Addendum No. 1

RE: Contract # C204728

Robeson County (I-5987B)

I-95 FROM SOUTH OF NC-20 TO SOUTH OF PROPOSED I-295.

REVISIONS						SHEET NO.
NO.	BY:	DATE:	NO.	BY:	DATE:	S4-29
1			3			TOTAL SHEETS
2			4			29

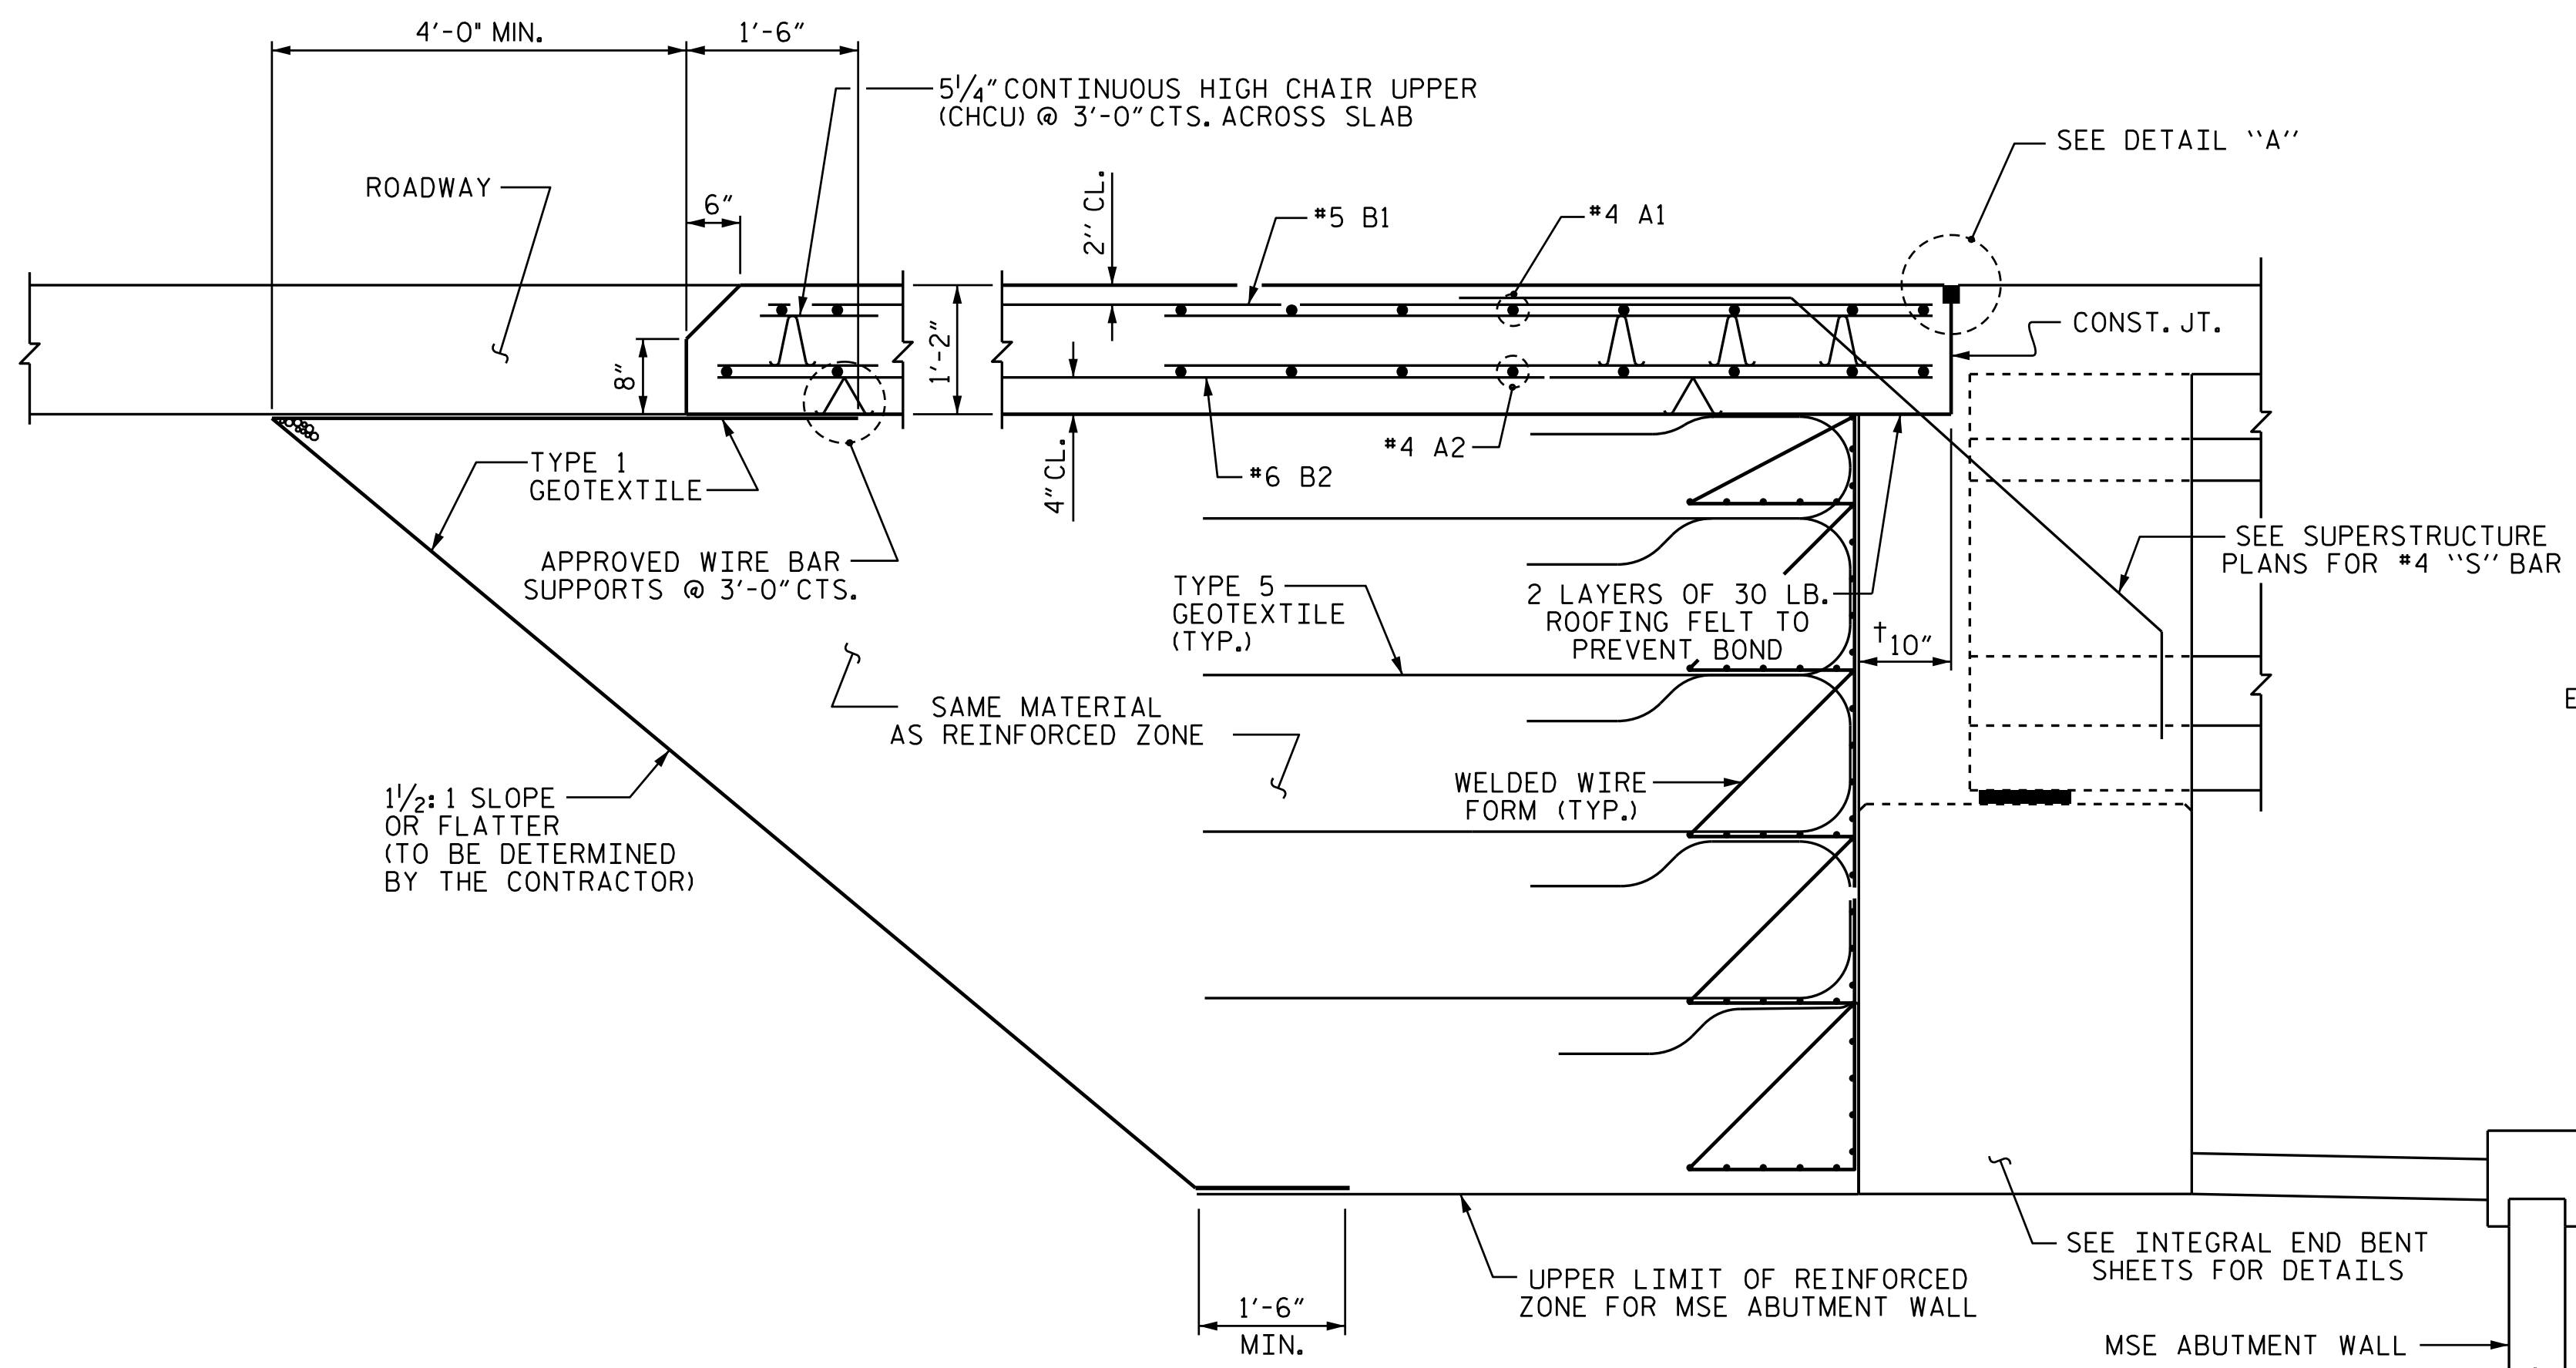
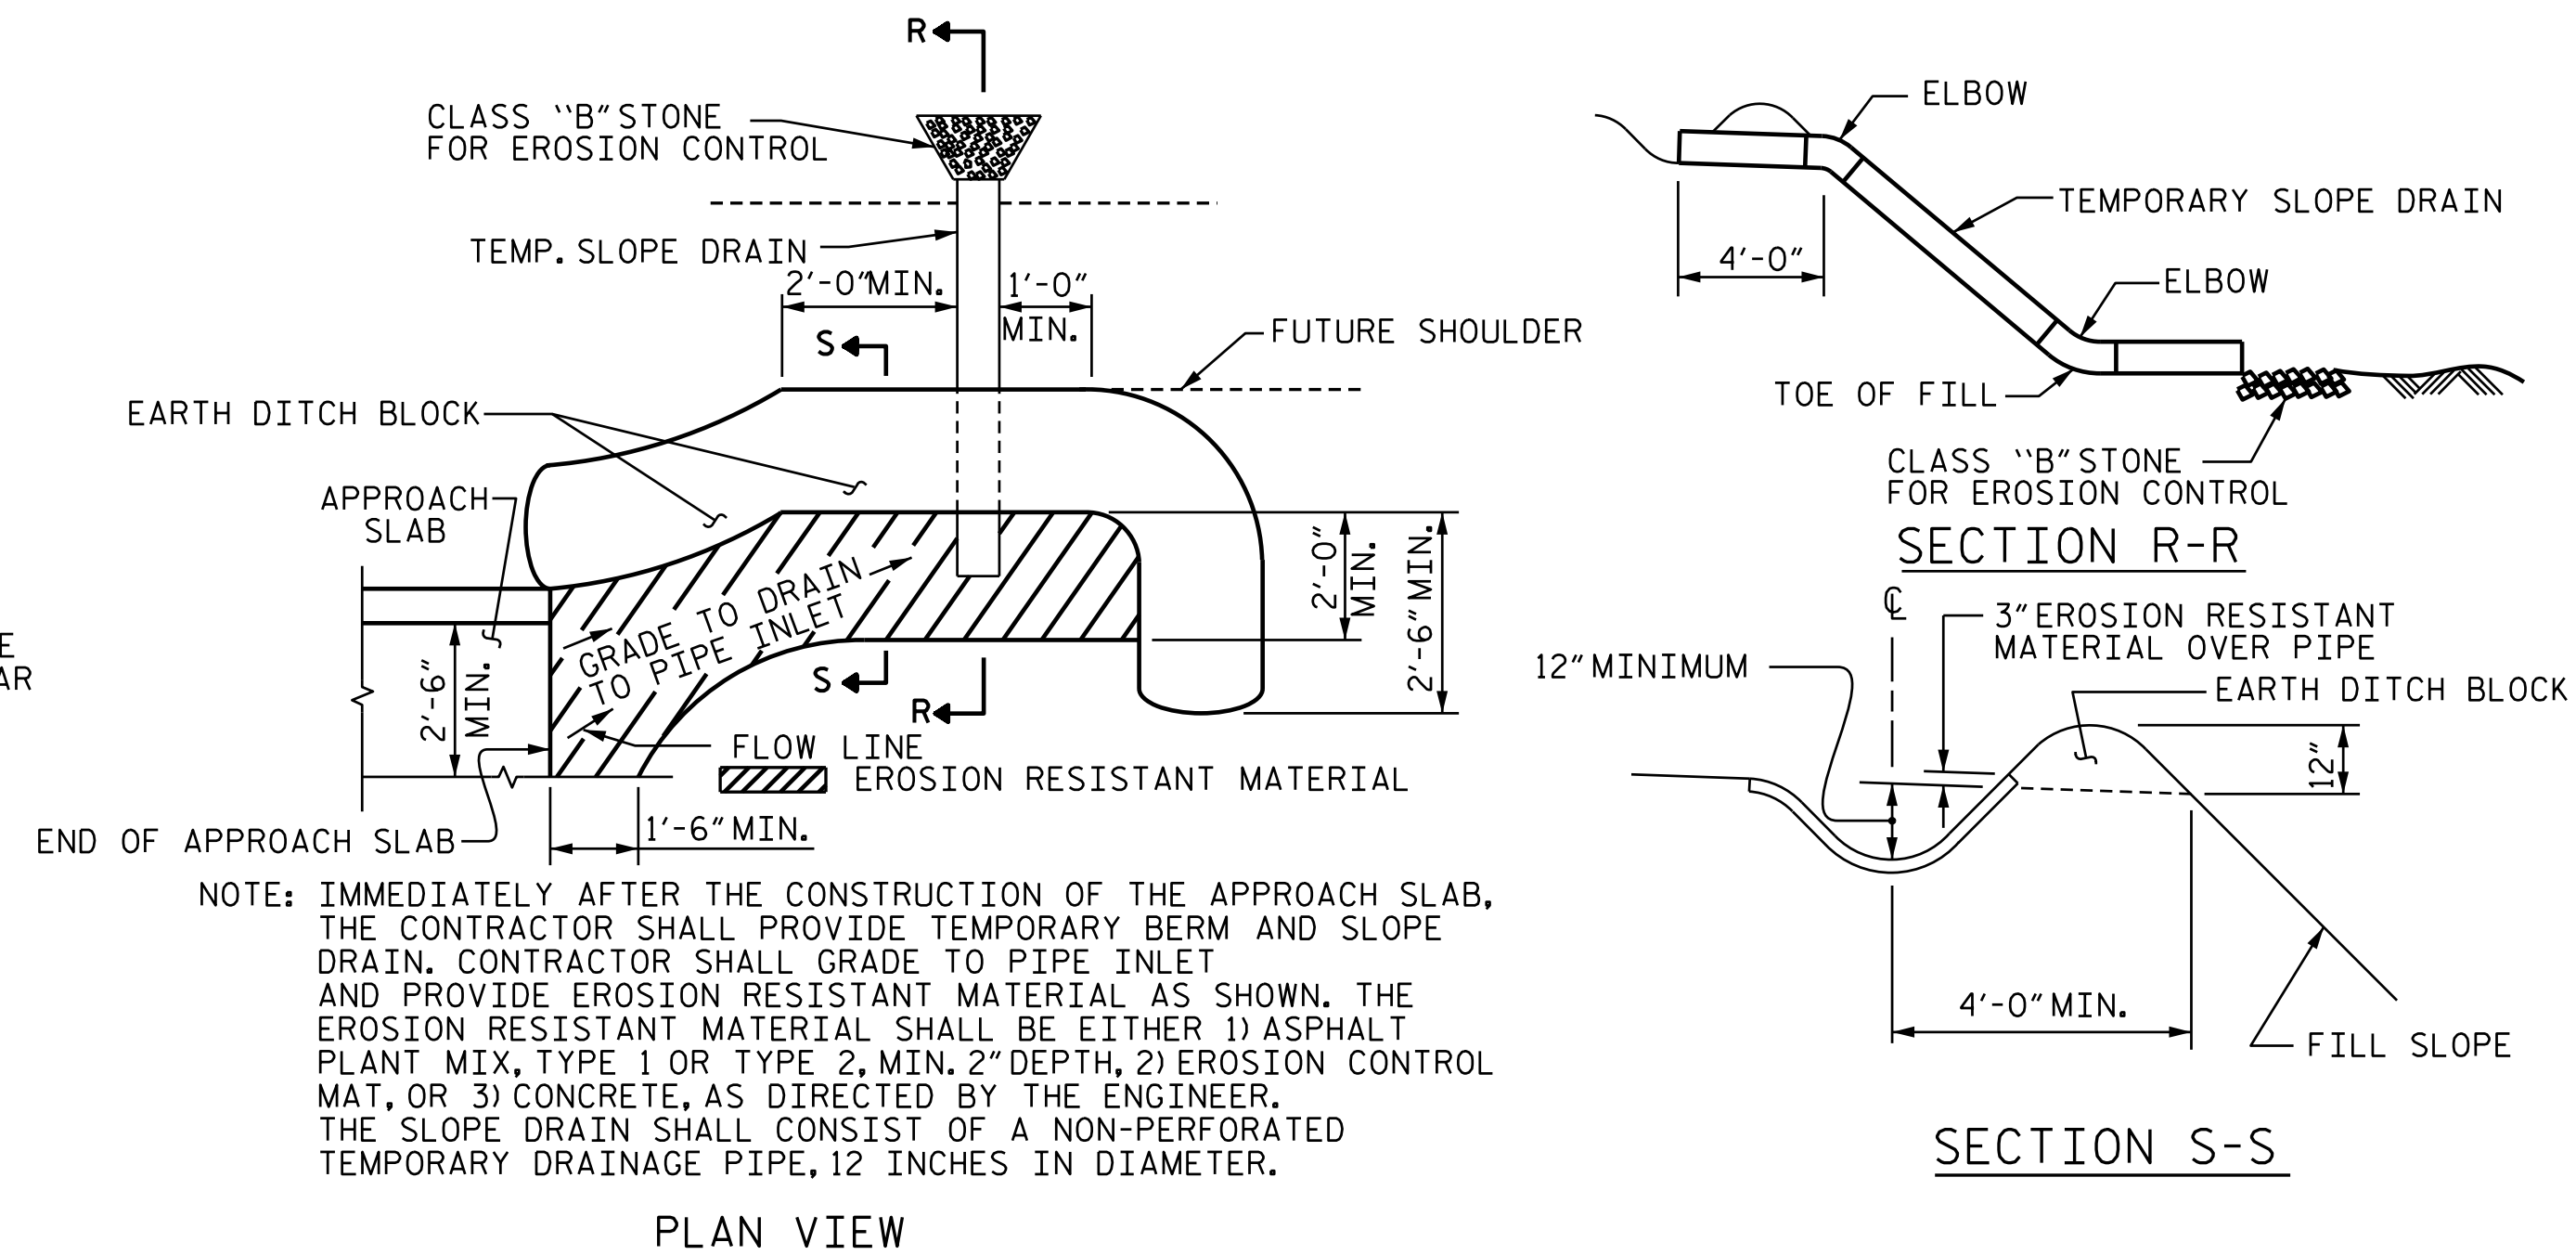
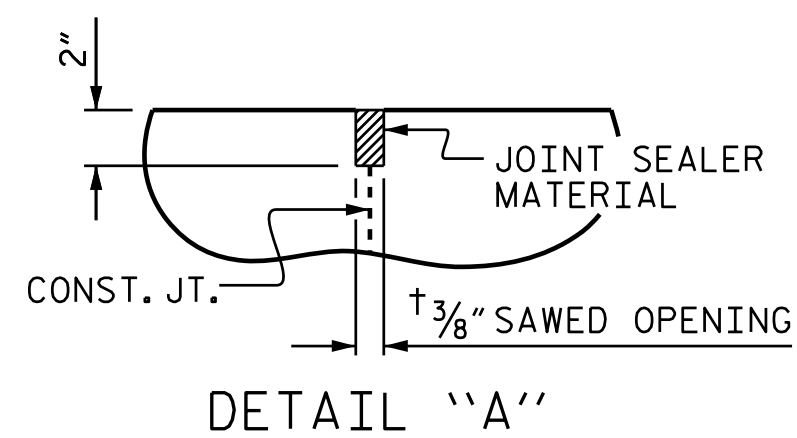
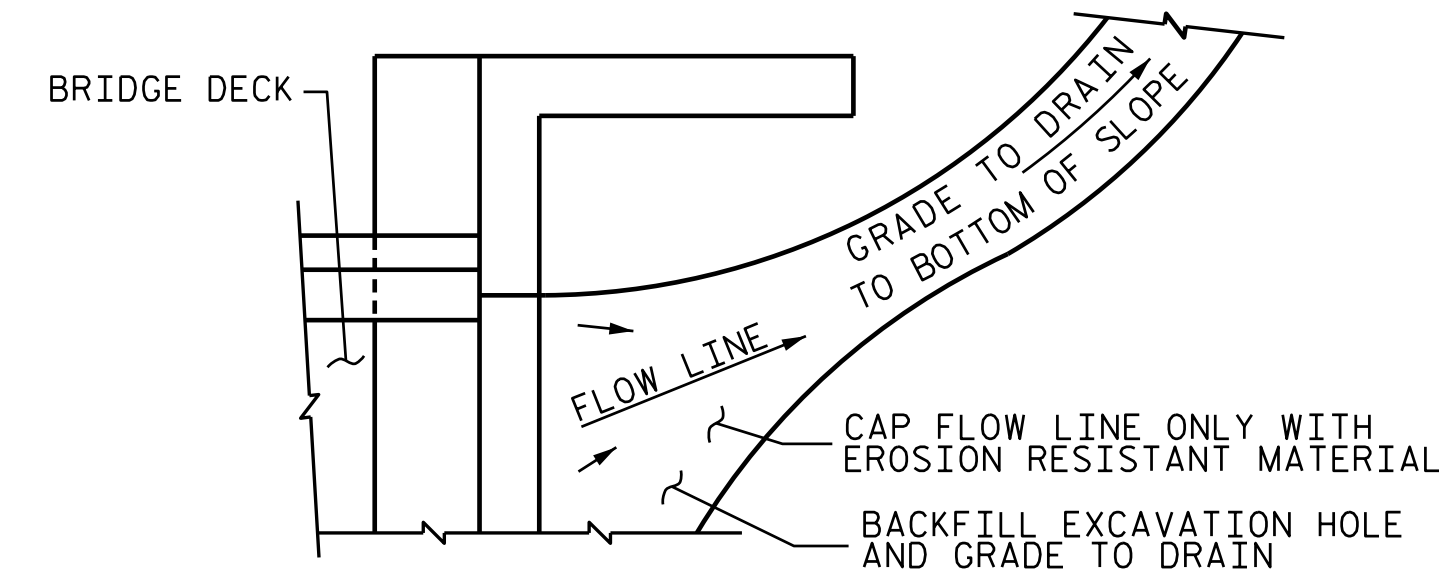
Sheet No.	Revision
S4-29 (New)	Bridge Approach Slabs Detail sheet added.
